# CHIPS AND TECHNOLOGIES, INC.

### CS8230 AT/386 CHIPSET DATASHEET ADDENDUM

JANUARY 27, 1989  
PA062.1/1-89  
Rev. 1.0

Followings are the addendum to the CS8230: AT/386 CHIPSet preliminary data sheet.

Figure 1.

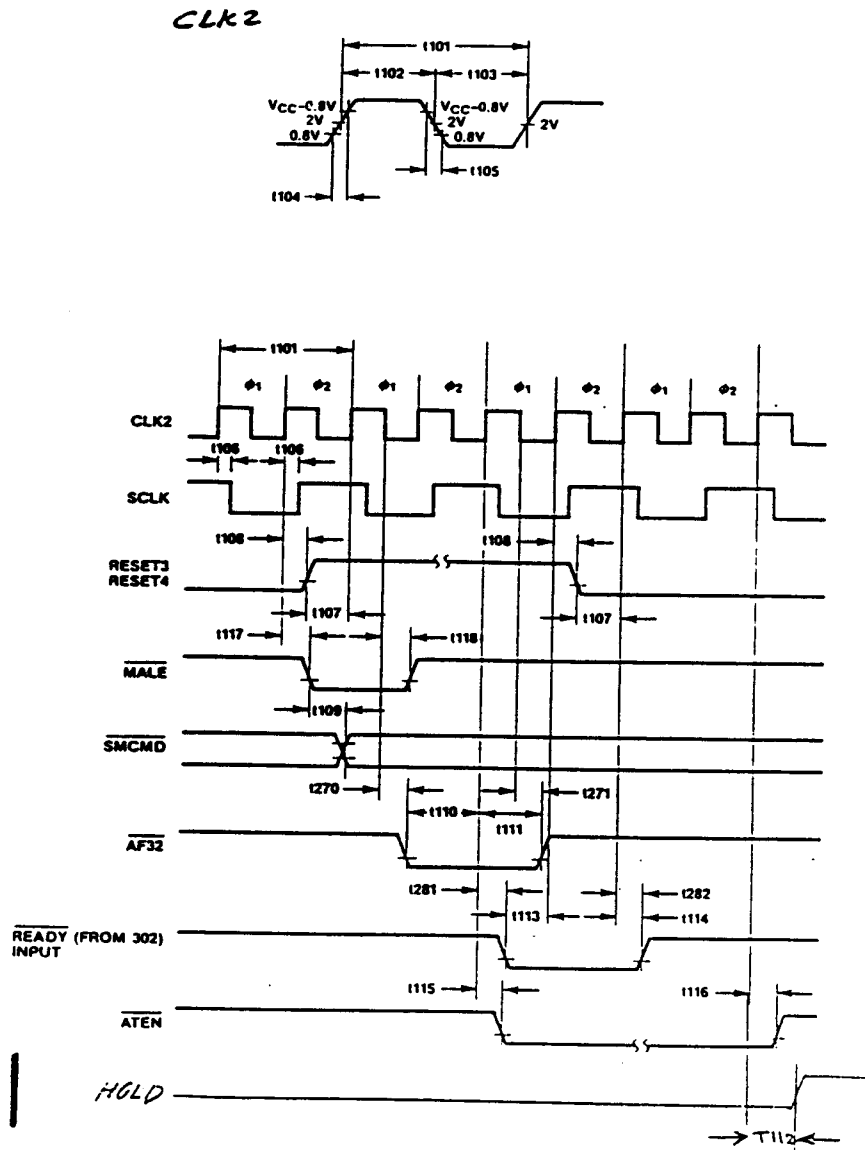
Page 38, the timing diagram is missing the HOLD signal. The timing diagram should be as shown in figure 1.

Figure 4.

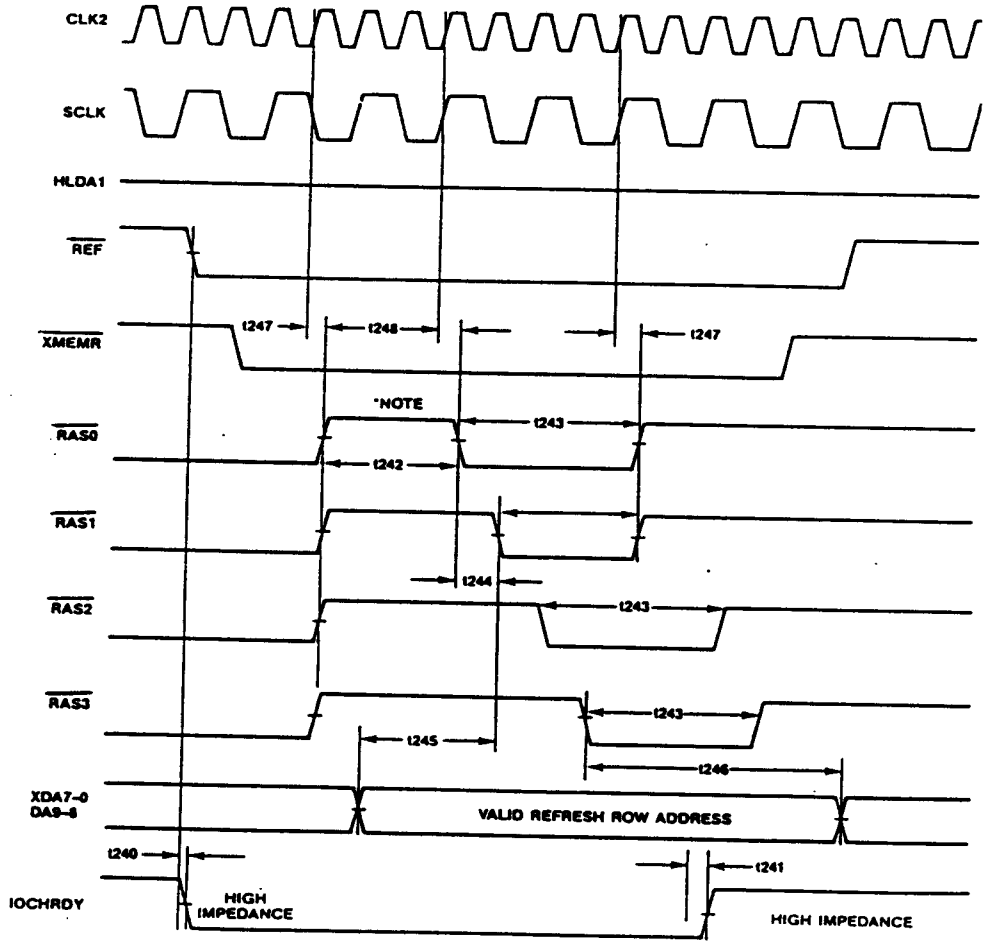
Page 62, the labels on some those timing diagram doesn't show a right polarity. It should be as shown in figure 4.

Figure 5.

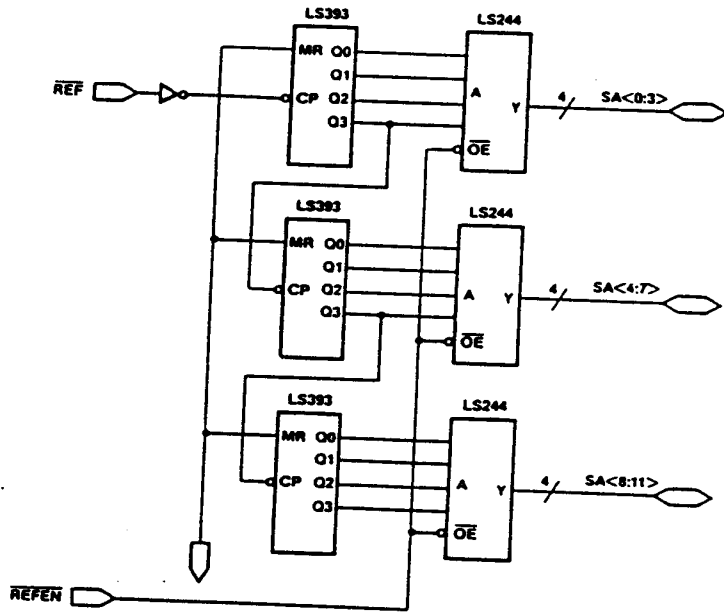
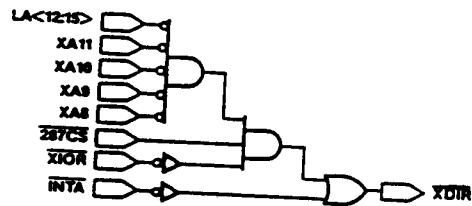
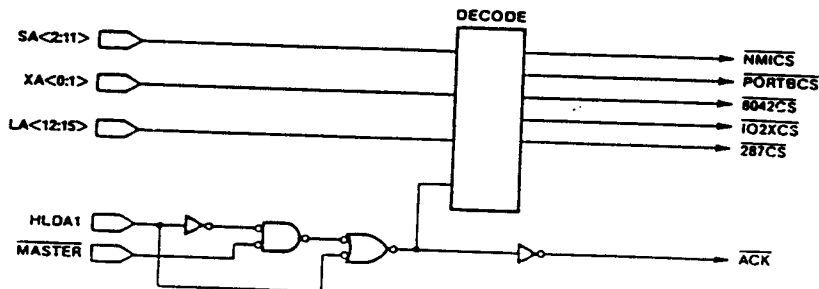
Page 84, all the labels are scrambled. It should be as shown in figure 5.

Figure 6.

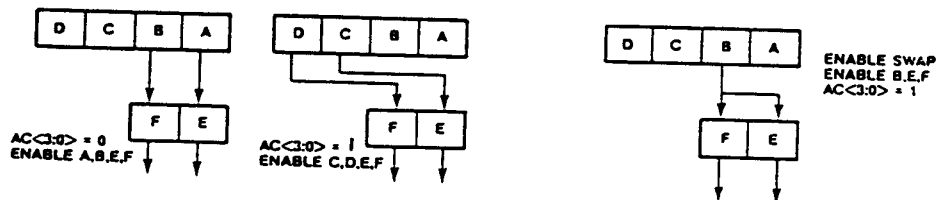
page 94, the write to 8 bit device diagram is missing some labels. It should be as shown in figure 6.

**FIGURE 7 A: READ CYCLE, PAGE HIT, NON-PIPELINED MODE, 1 WS, 20 MHz.**

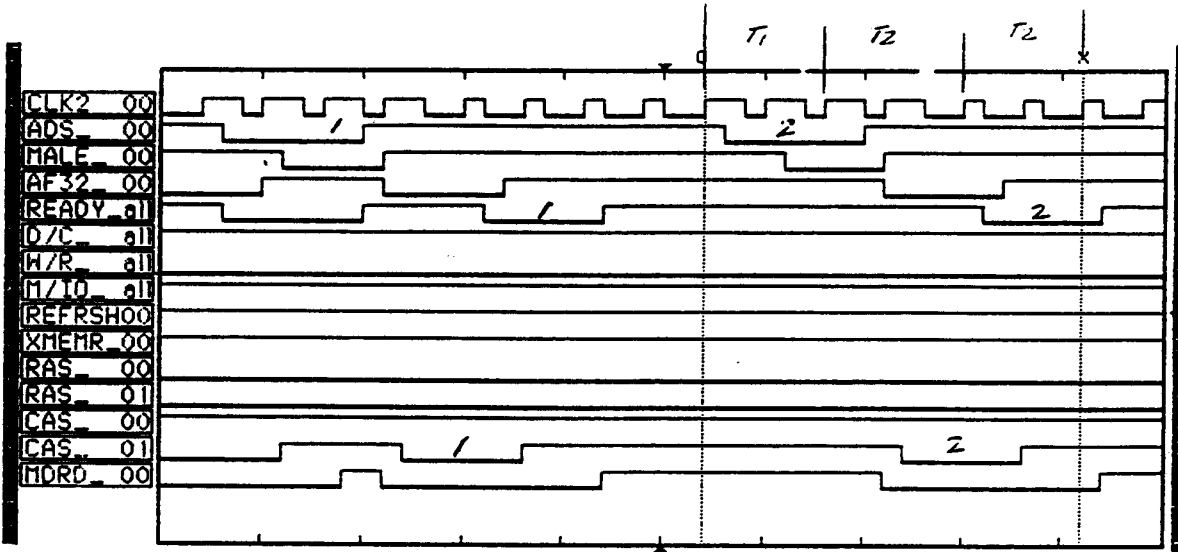
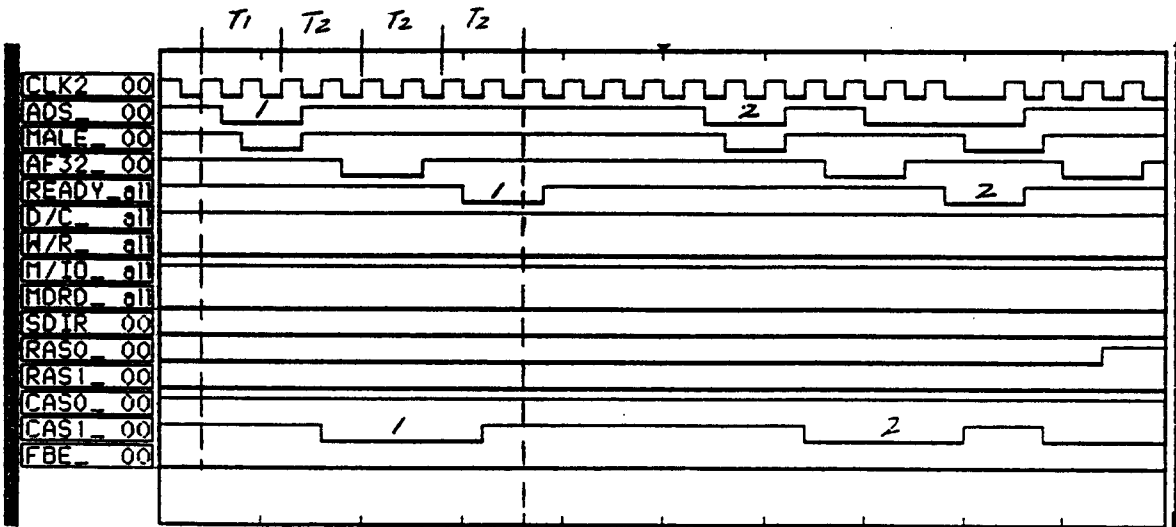
The main timing differences between the 20 MHz and 25 MHz CS8230 are in their local memory cycles. Following timing diagrams illustrates most of the local memory cycles for 20 and 25 MHz and point out the differences.

Figure 7 A&B show the timing diagrams for read cycle, page hit, non-pipelined mode for 20 and 25 MHz respectively.

FIGURE 8 A: READ CYCLE, PAGE HIT, PIPELINED MODE, 0 WS, 20 MHz.

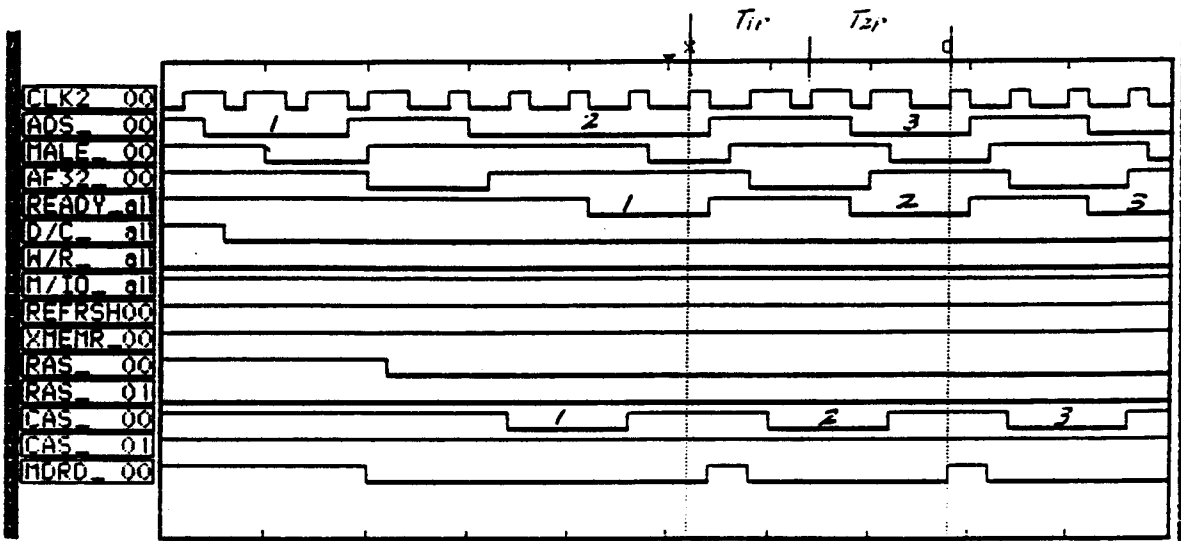
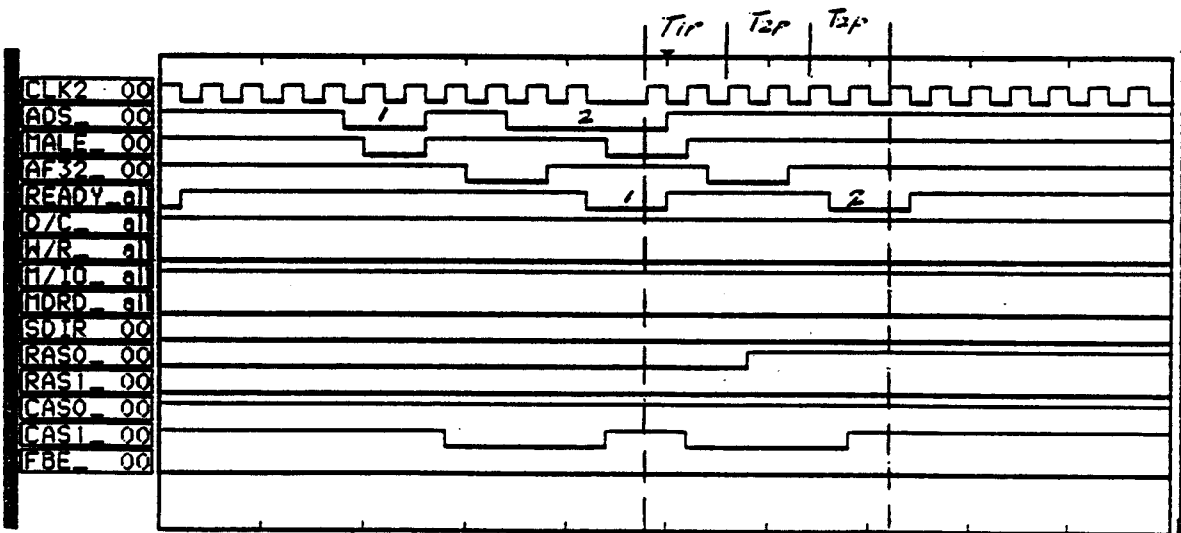
Figure 8 A&B show the timing diagrams for read cycle, page hit, pipelined mode for 20 and 25 MHz respectively.

**FIGURE 9 A: READ CYCLE, RAS BEING INACTIVE, NON-PIPELINED MODE, 2 WS, 20 MHz.**

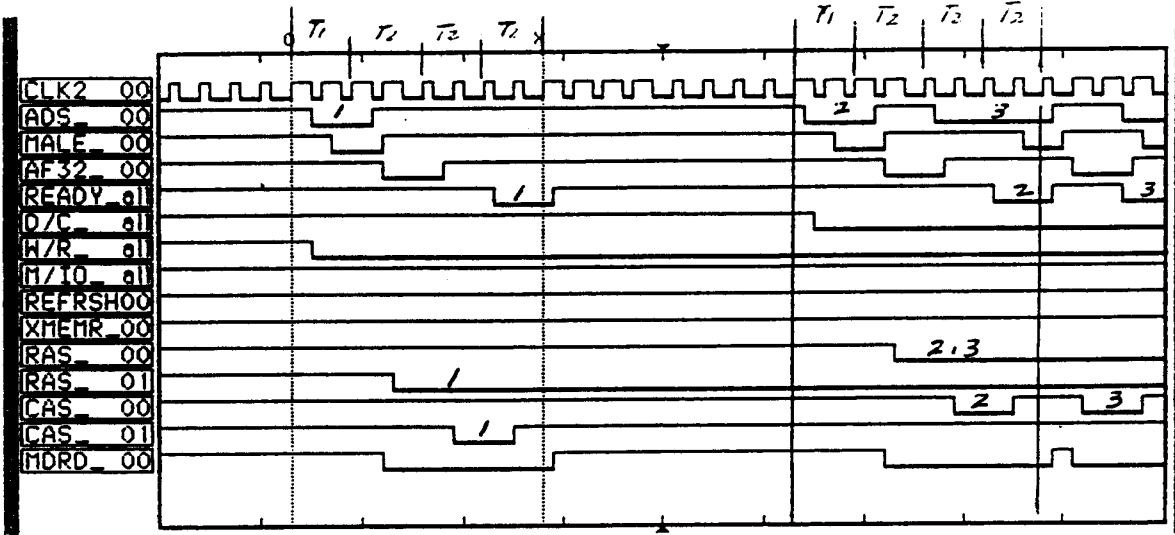
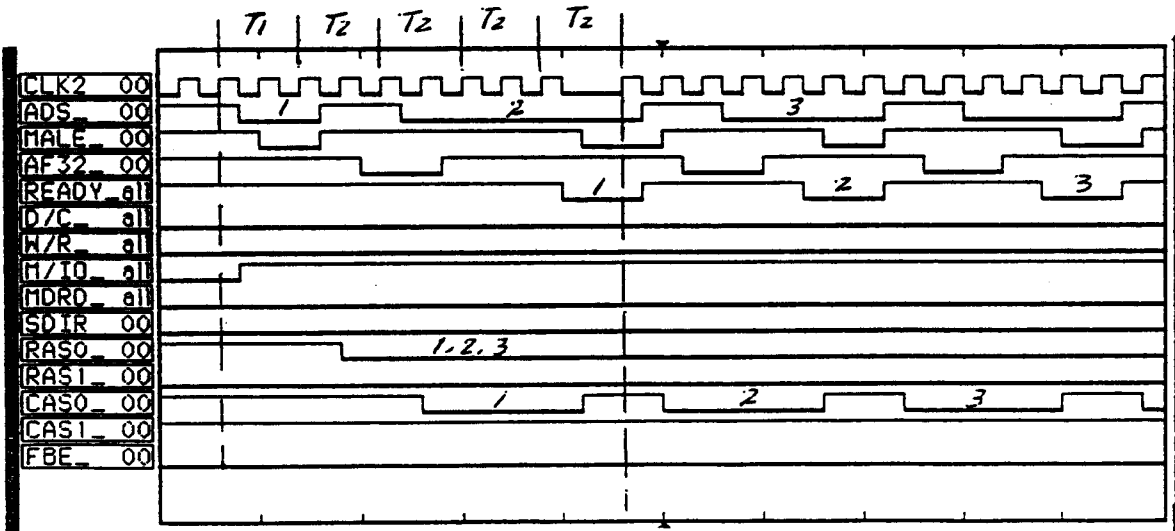
Figure 9 A&B show the timing diagrams for read cycle, RAS being inactive, non-pipelined mode for 20 and 25 MHz respectively.

FIGURE 10 A: READ CYCLE, PAGE MISS, NON-PIPELINED MODE, 4 WS, 20 MHz.

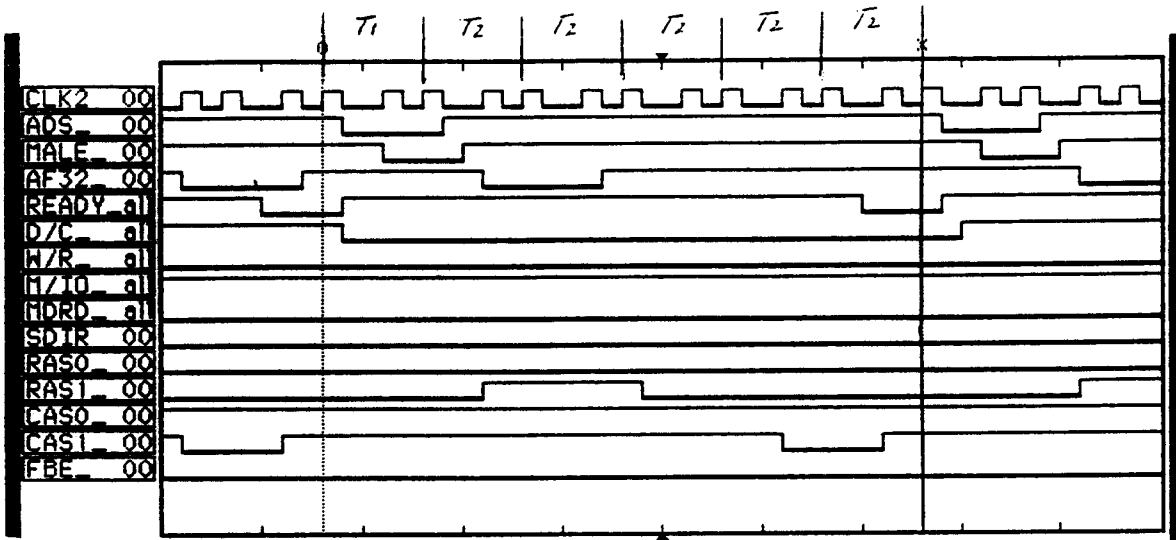
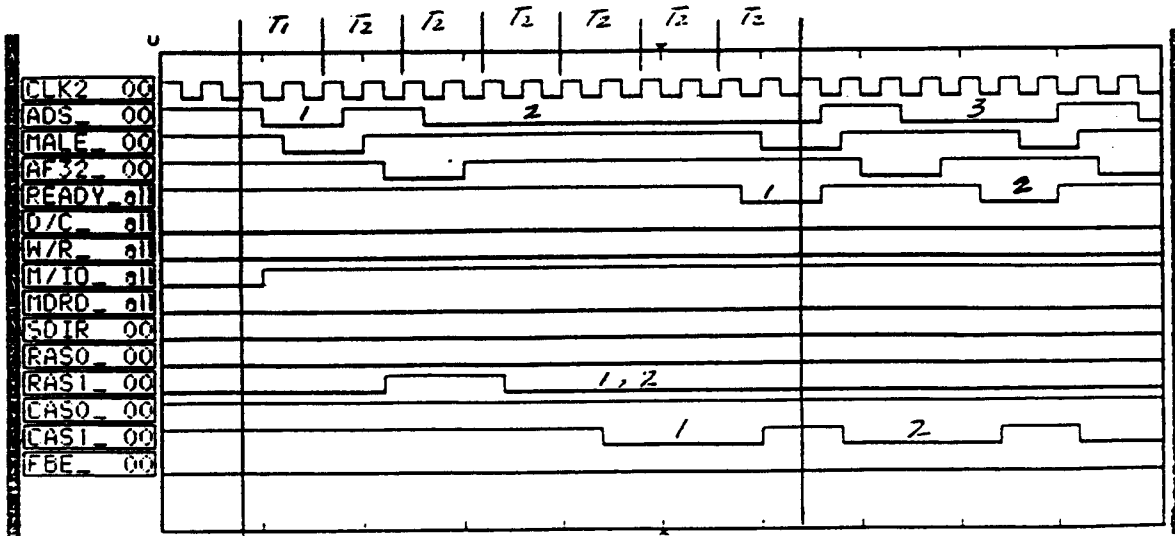
Figure 10 A&B show the timing diagrams for read cycle, page miss, non-pipelined mode for 20 and 25 MHz respectively.

FIGURE 11 A: WRITED CYCLE, PAGE HIT, PIPELINED MODE, 1 WS, 20 MHz.

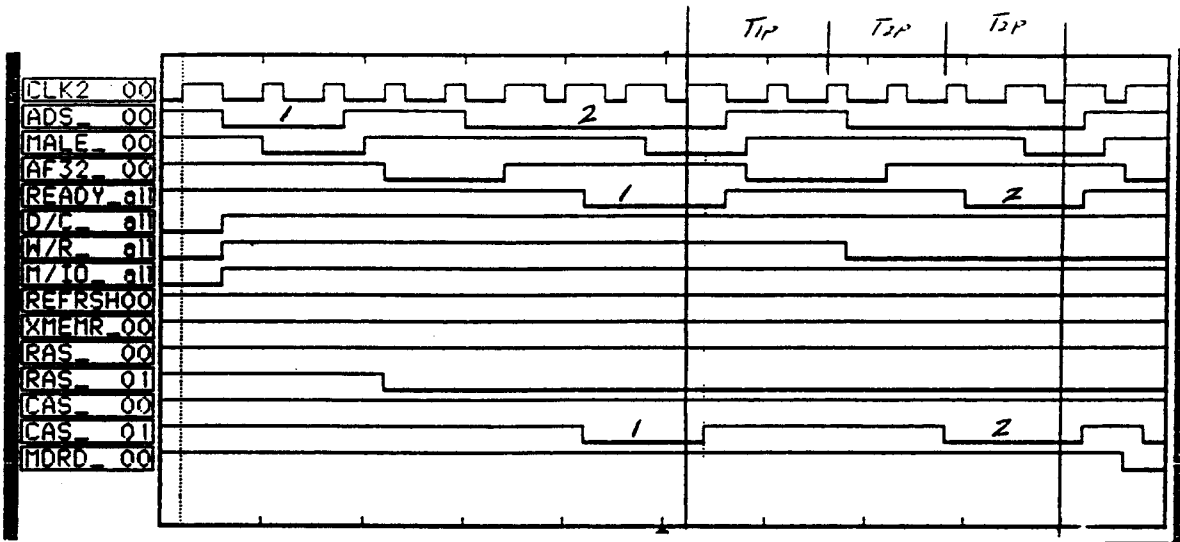
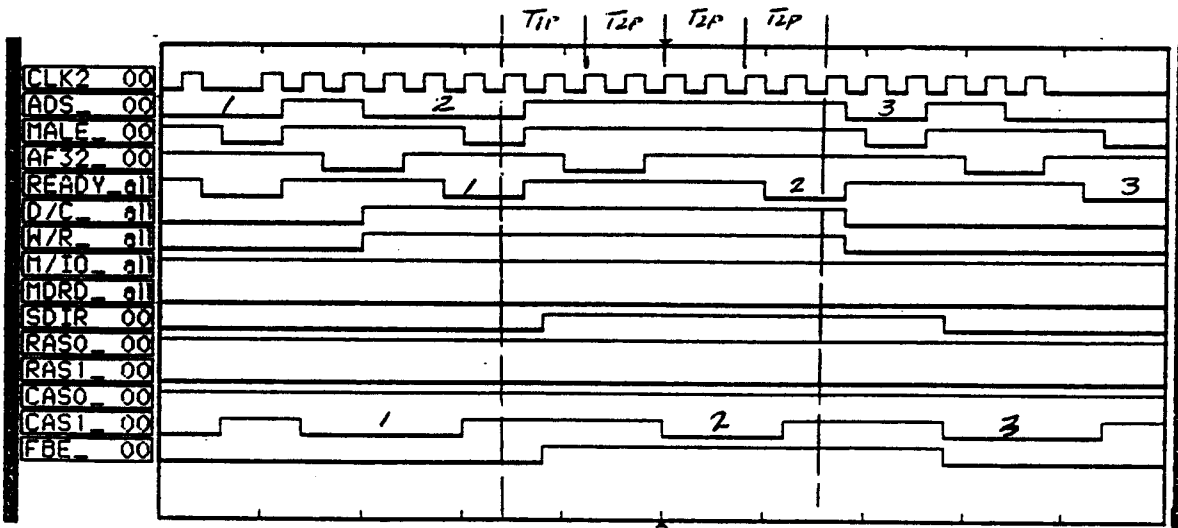
Figure 11 A&B show the timing diagrams for write cycle, page hit, pipelined mode for 20 and 25 MHz respectively.

**FIGURE 12 A: WRITE CYCLE, PAGE MISS, NON-PIPELINED MODE, 4 WS, 20 MHz.**

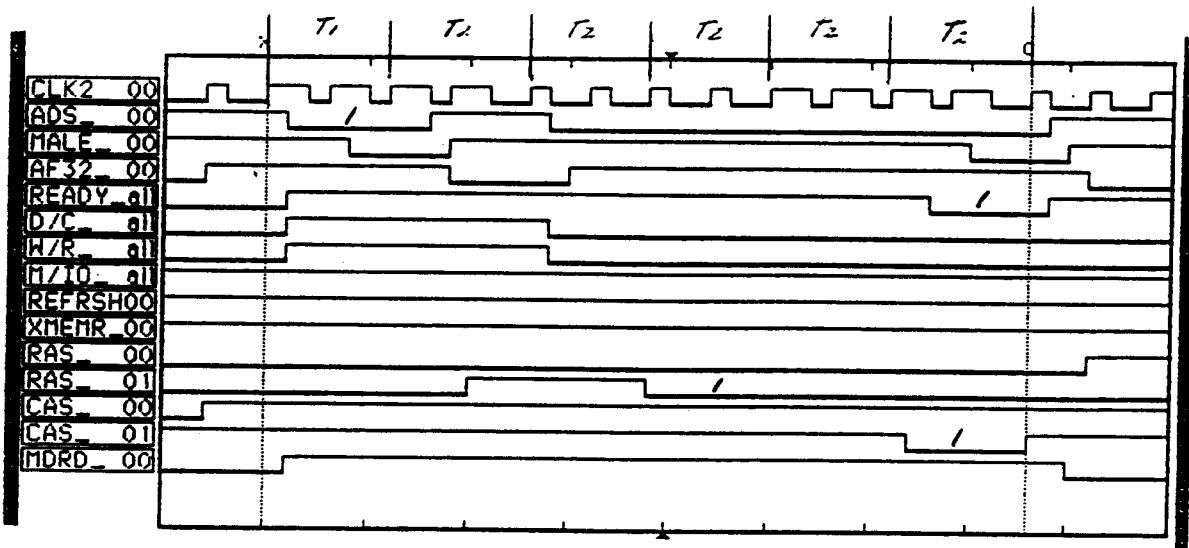
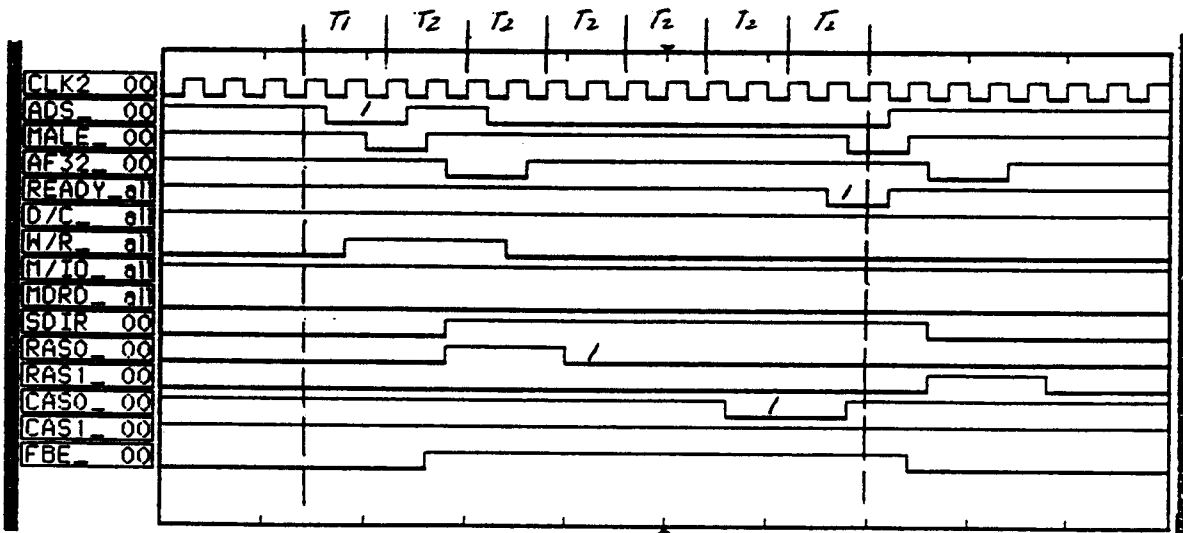
Figure 12 A&B show the timing diagrams for write cycle, page miss, non-pipelined mode for 20 and 25 MHz respectively.

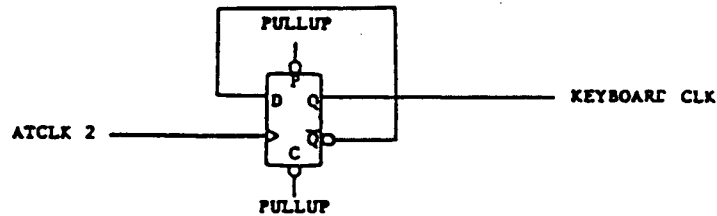
- (1) **Anomaly:** SDIR generation is incorrect and causes the buffers to be in the wrong direction on the local and AT bus for some access cycles.
- Fix:** The following circuit shows the fix needed for correct SDIR signal generation.
- Plan:** Corrected in the next revision of silicon.

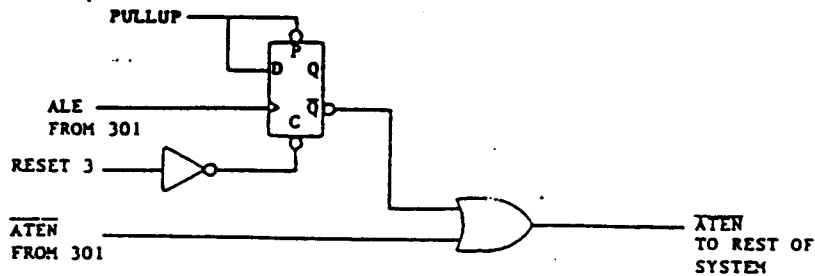
- (2) **Anomaly:** PCLK generation during RESET: PCLK is inhibited during the reset which causes keyboard controller not to reset correctly.
- Fix:** The following external fix should be provided so that devices such as the keyboard controller can be reset correctly. Note that this fix assumes the use of asynchronous AT clock: if AT clock is derived from the CLK2, a divide down from CLK2 would be needed.
- Plan:** Corrected in the next revision of silicon.
